Model: Bellini		Date: 31-Jan-00	No.: MA294001
Modified Article: Parts Catalog		Prepared by: H. K.	
From: Technical Services Dept., GTS Division			
Reason for Modification:	☒ Parts catalog correction ☐ To facilitate assembly ☐ Part standardization	☐ Vendor change ☐ To improve reliability ☐ Other	☐ To meet standards ()

Model: Bellini		Date: 29-Feb-00	No.: MA294002
Modified Article: Rear Fusing Plate & Right Lower Fusing Stay		Prepared by: H. Kobayashi	
From: Technical Services Dept., GTS Division			
Reason for Modification:	☐ Parts catalog correction ☐ To facilitate assembly ☐ Part standardization	☐ Vendor change ☒ To improve reliability ☐ Other	☐ To meet standards ()

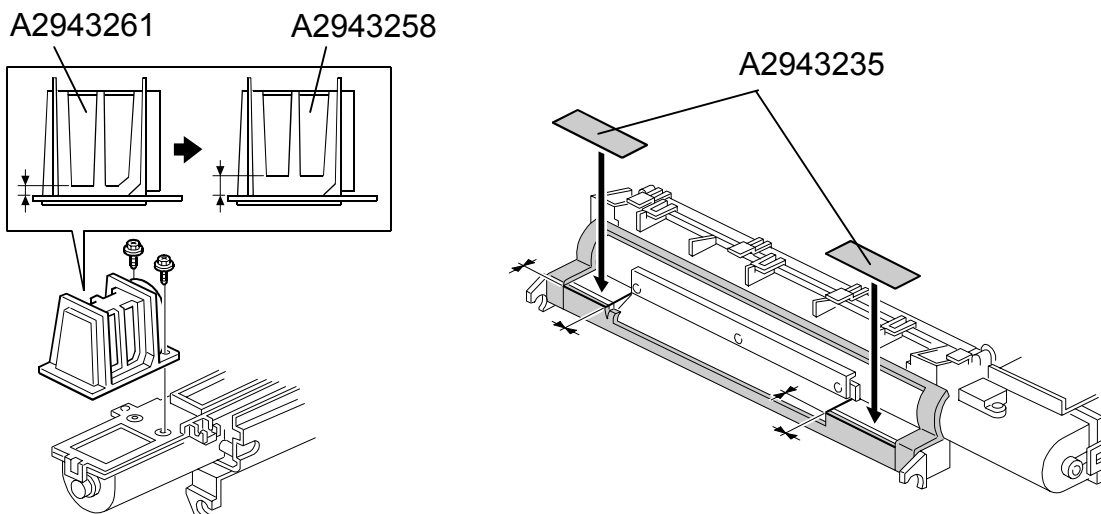
1. To ensure that toner does not leak from the toner supply unit (toner hopper) casing, the material of the seals has been changed to a high-density type of sponge (indices 7, 8, 9, 10, 14, 24, 25, 26 - p. 83). Additionally, the width of AA151794 (index 26) has been increased from 5 to 10 mm.
2. To seal two gaps in the toner supply unit casing, two seals have been added to the toner supply unit.
3. To ensure that toner does not leak from the toner hopper joint (index 3 - p. 83), the shape of the toner hopper joint has been modified as shown below.
4. To minimize toner dusting from both sides of the development unit, the material of the development unit side seals has been changed (indices 4, 5 - p. 87).

1. For machines without the A2949502 seal from the enhancement kit (A2949901) or machines in which this seal has come off, please replace the AA141794 seal with the new A2943238 seal. This will have the same effect. Please refer to RTB RA294018.
2. Just as with Note 1 above, please replace the A2943237 seal with the new AA141793 seal, instead of replacing the A2949505 seal from the enhancement kit. Please refer to RTB RA294018.
3. A2943235 can be used to replace A2949503 or A2949504, both of which are contained in enhancement kit A2949901. To replace A2949503 with the new seal A2943235, cut the new seal to 47 mm.

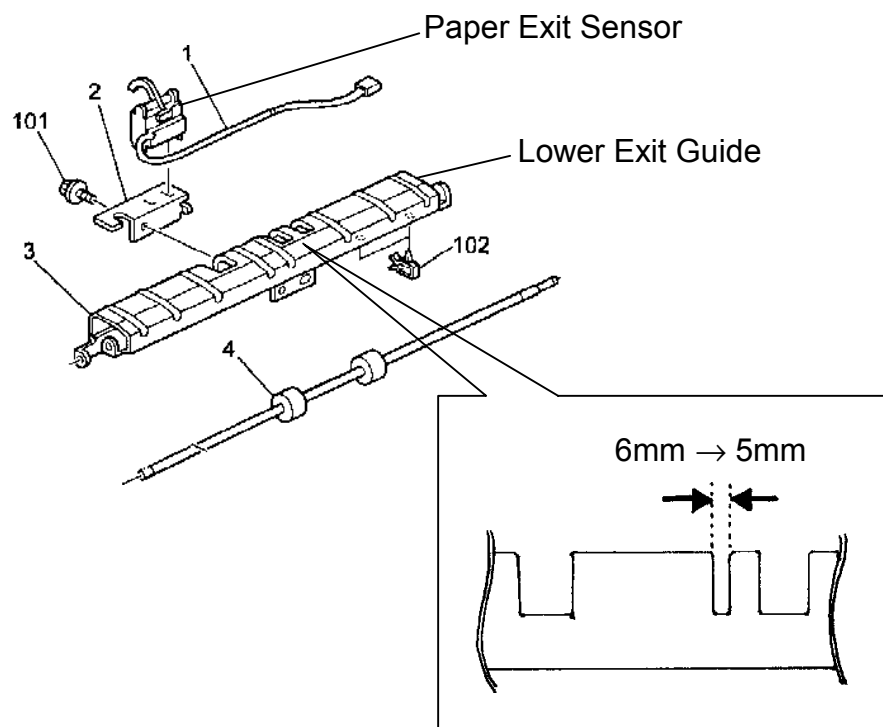
The cut-out in the lower exit guide for the paper exit sensor feeler has been narrowed to ensure that the feeler is not broken off during removal of jammed paper.

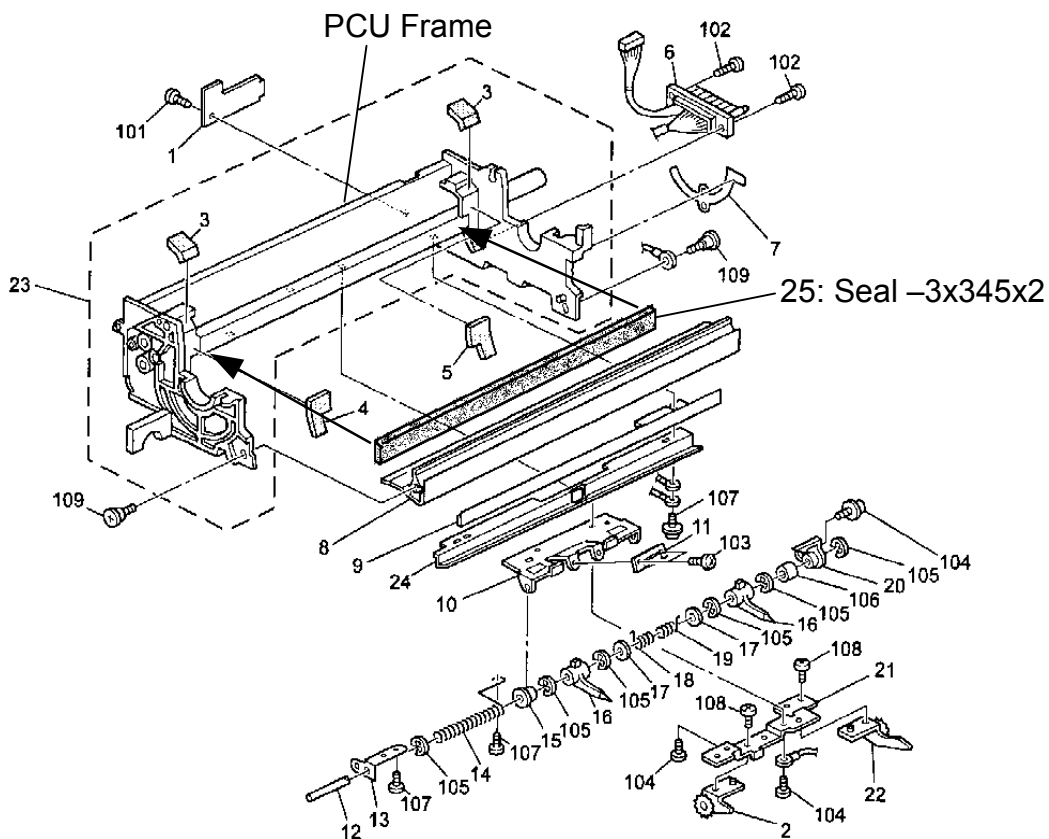
A sponge has been added to the PCU Frame to ensure that toner does not drop from the gap between the frame and the drum.

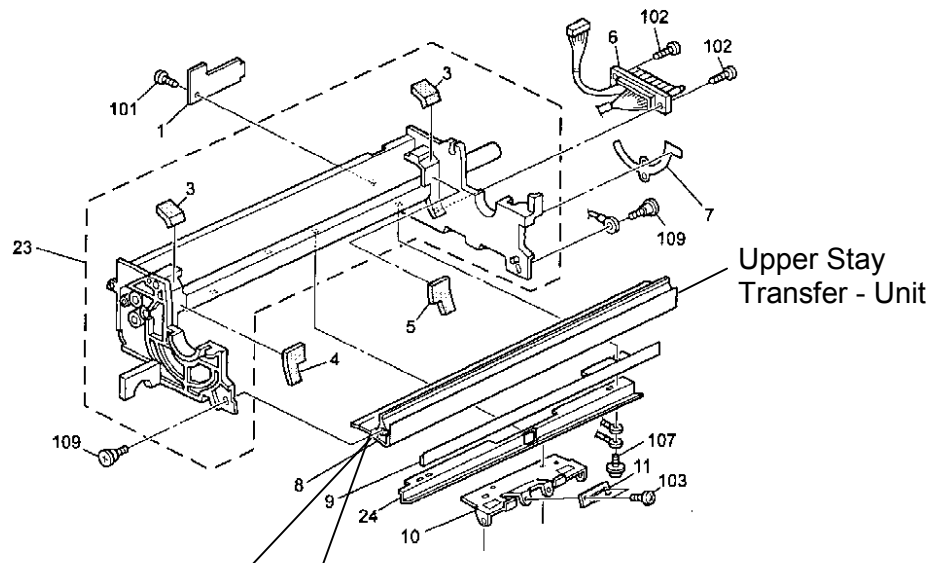
The edge shape of the Upper Stay – Transfer Unit has been changed to increase the clearance between the edge and the drum surface. This is to prevent toner from accumulating on the edge of the upper stay.

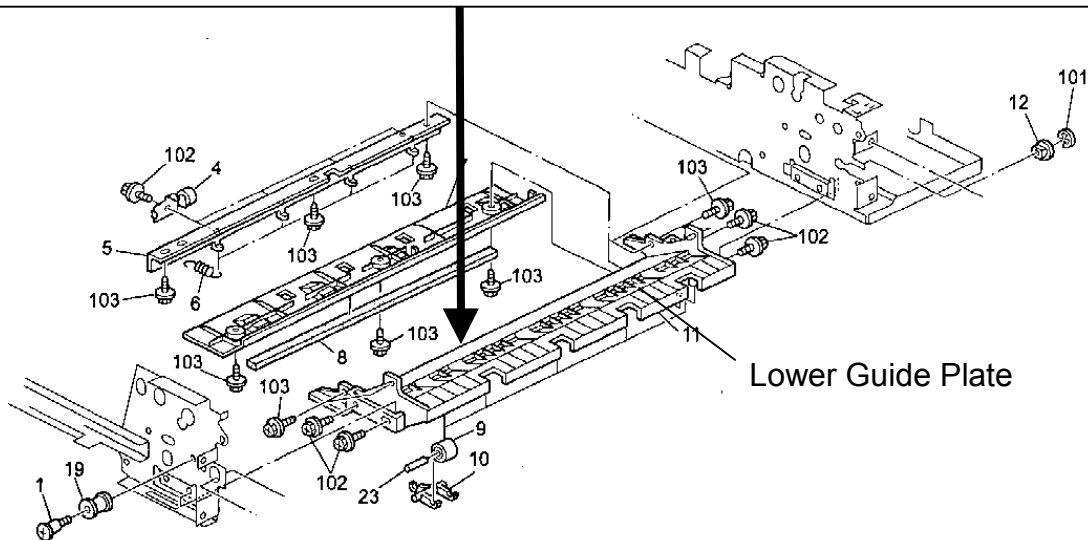
The design specifications of the Lower Guide Plate have been changed to improve the flatness of the edge as shown below.

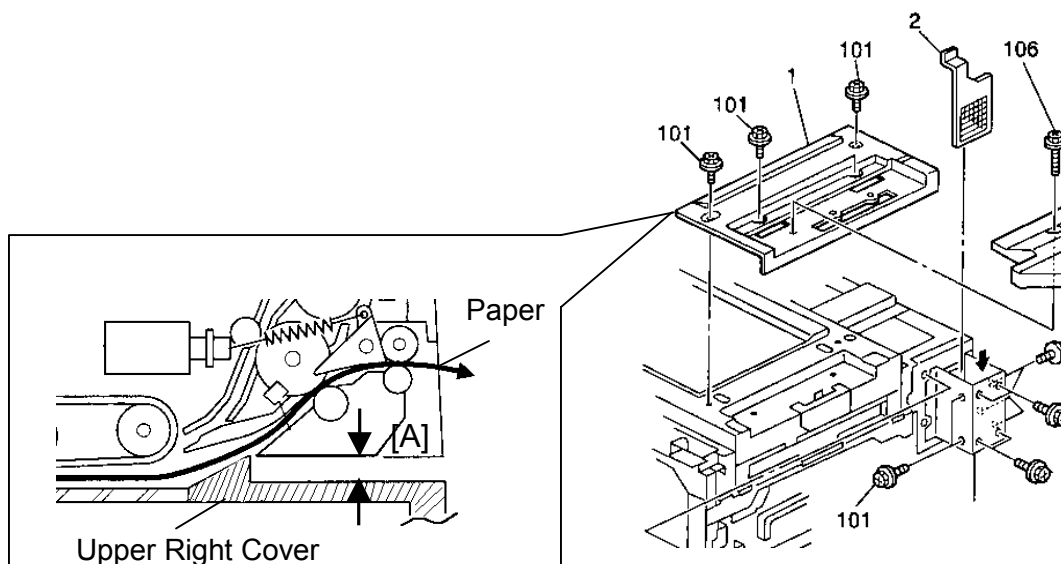
Dimension [A] of the upper right cover has been increased by 2 mm to ensure proper feeding of originals.

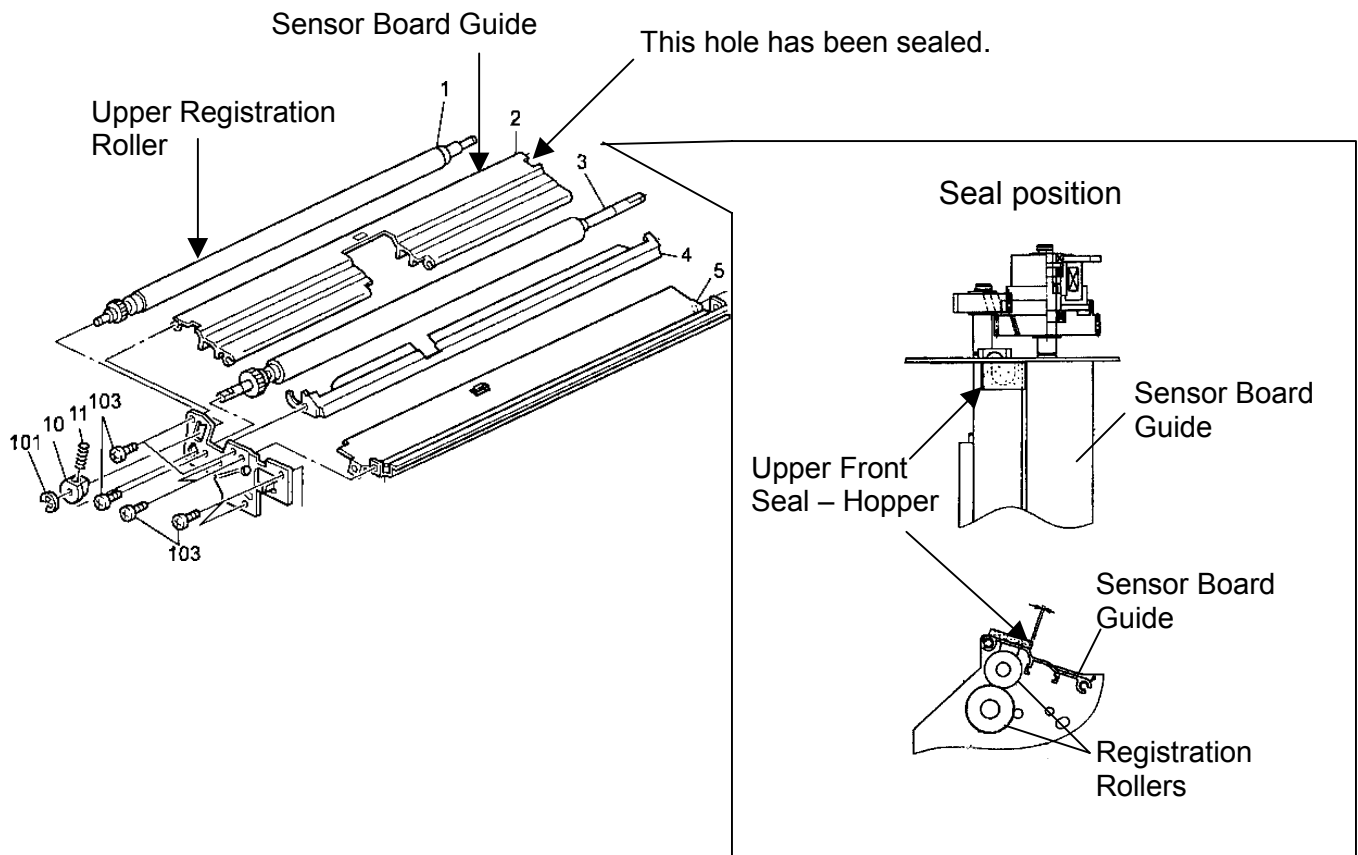
The foam seal (Upper Front Seal – Hopper) has been added to the Sensor Board Guide to prevent the scattered toner from dropping on the registration rollers.

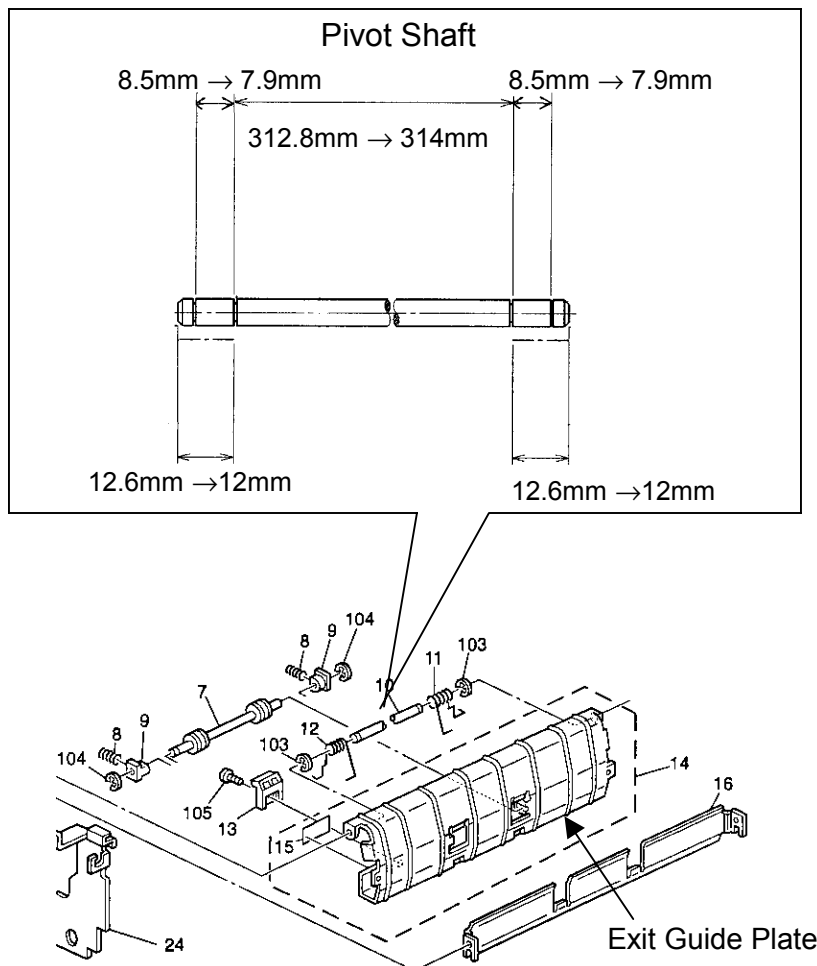
The e-ring positions on the pivot shaft have been changed to reduce side-to-side play of the exit guide plate.

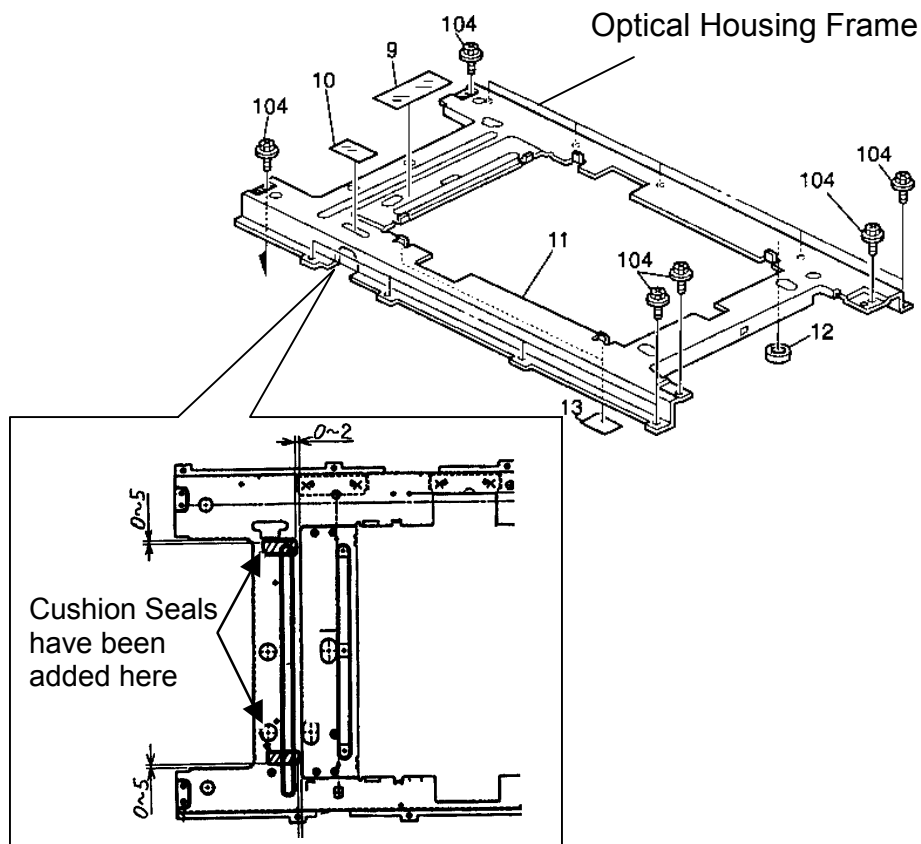
Two cushion seals have been added to the optical housing frame to prevent frame damage during machine transportation.

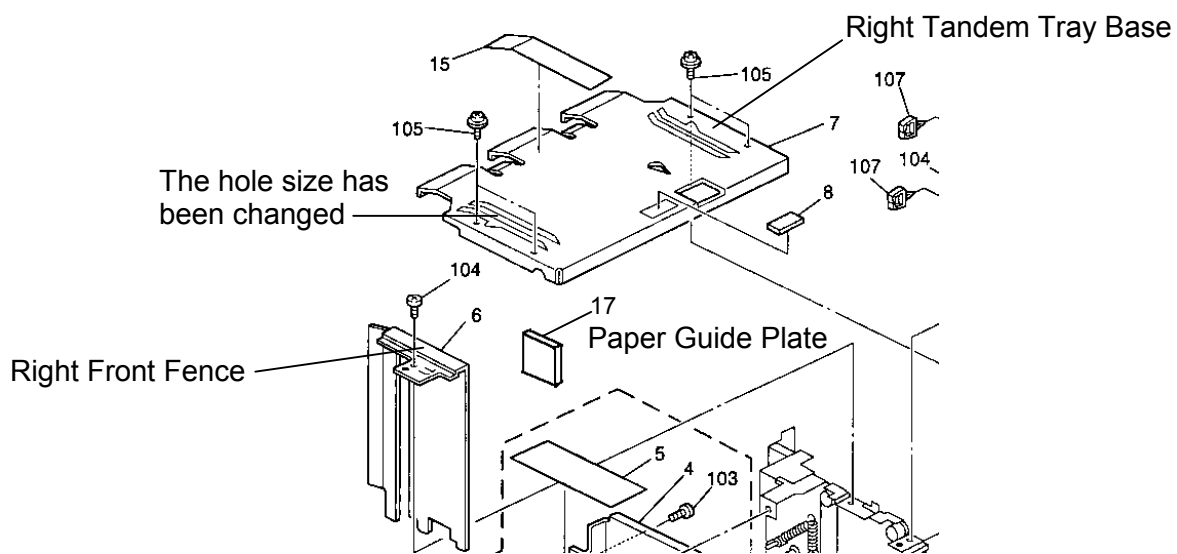
The shape of the fence has also been changed for the paper guide plate. The size of the fence set holes on the tray base have also been changed.

The new right front fence (P/N A294-6739) includes the paper guide plate (P/N A096-6671).

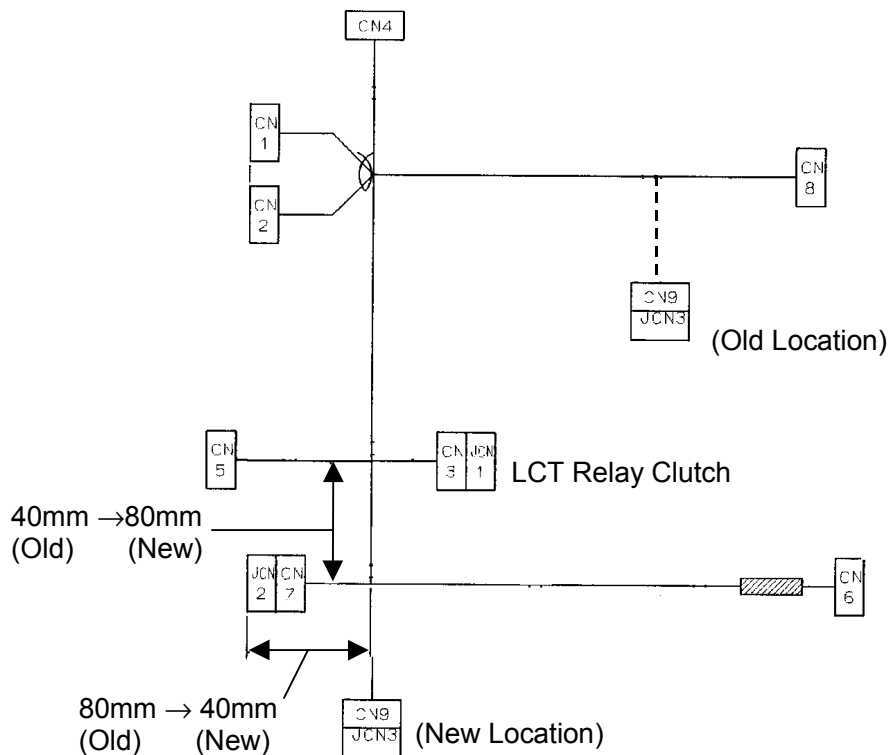
The Paper Feed Unit Harness has been changed as shown in the illustration below to prevent the harness from being pinched under the lower left hand corner of the development drive motor.

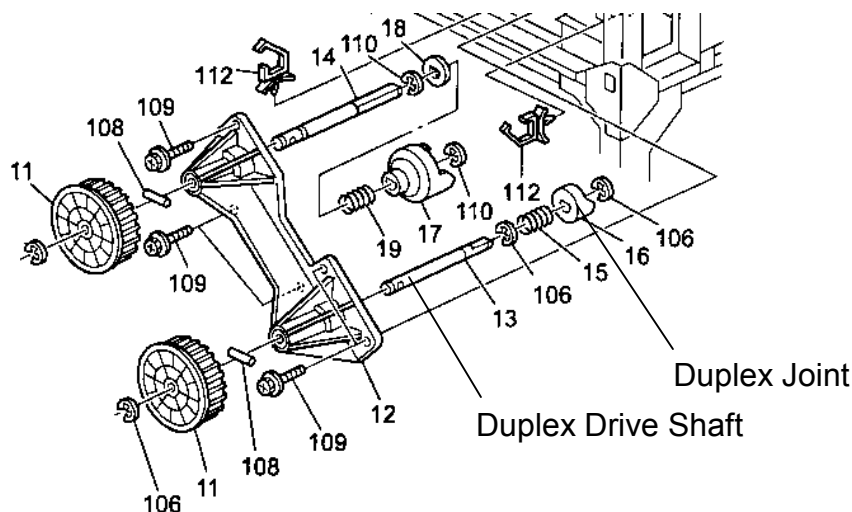
The surface of the duplex drive shaft has been improved to make duplex joint movement smoother.

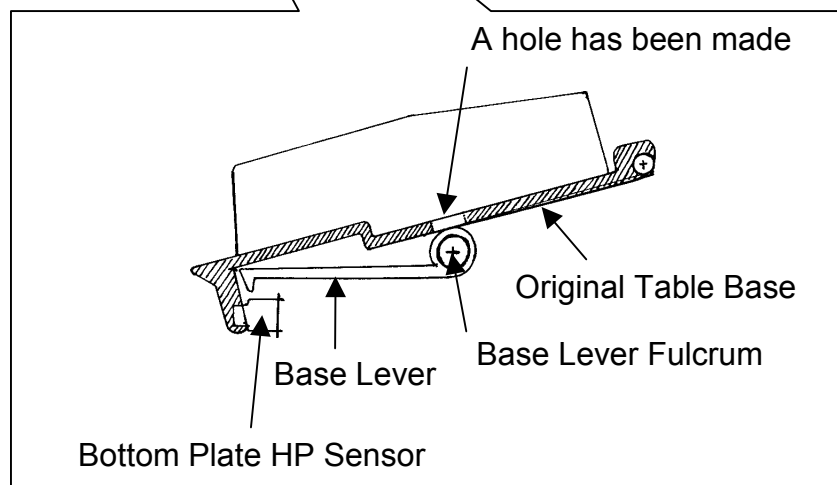
A hole has been made in the original table base to prevent the original table base from hitting the base lever fulcrum and to ensure that the bottom plate HP sensor is actuated.

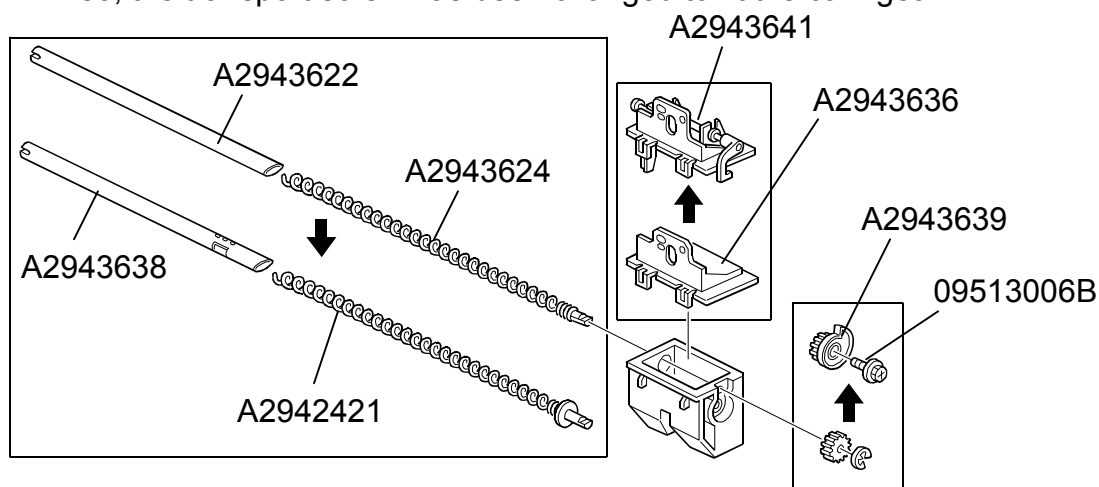
To enable a 60% toner recycling (40% cut), the toner recycling mechanism has been modified. Specifically, the following changes have been made:

1. Three holes have been added to the toner recycling pipe. When the recycling pipe is positioned with the holes facing down, 60% of the toner is sent to the toner bank to be recycled, while the remaining 40% drops from the holes into the toner collection bottle.
2. A mechanism to tap the toner recycling pipe has been added to the upper case. This mechanism is necessary to prevent used toner from blocking the holes when 40% toner cut is selected.
3. In order to drive the tapping mechanism, the upper 17Z gear has been changed to one with a cam. Also, the transport screw has been changed to fit the cam gear.

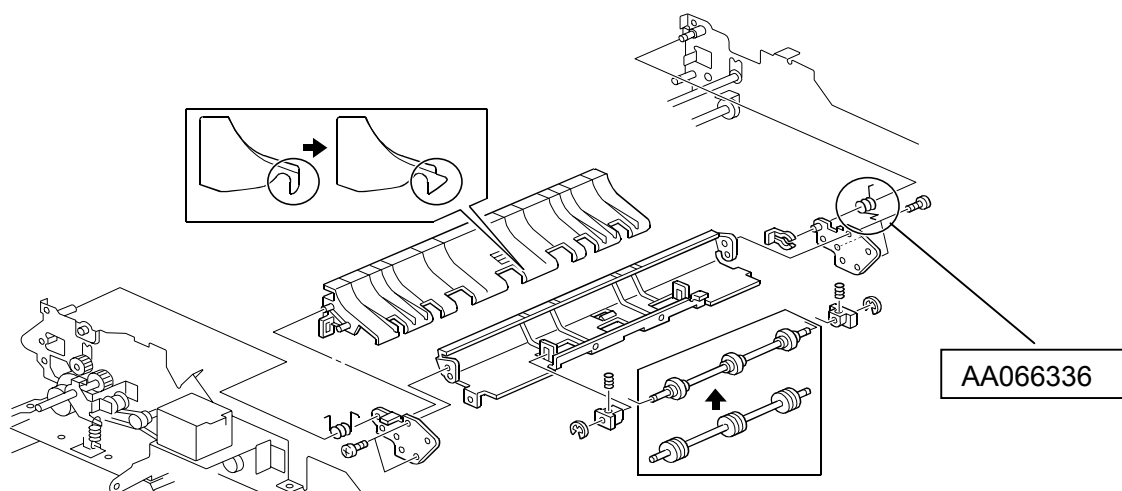
Black lines may appear on the side edge of stacked copies when more copies are stacked. To ensure good copy quality, the production machines have been modified as follows:
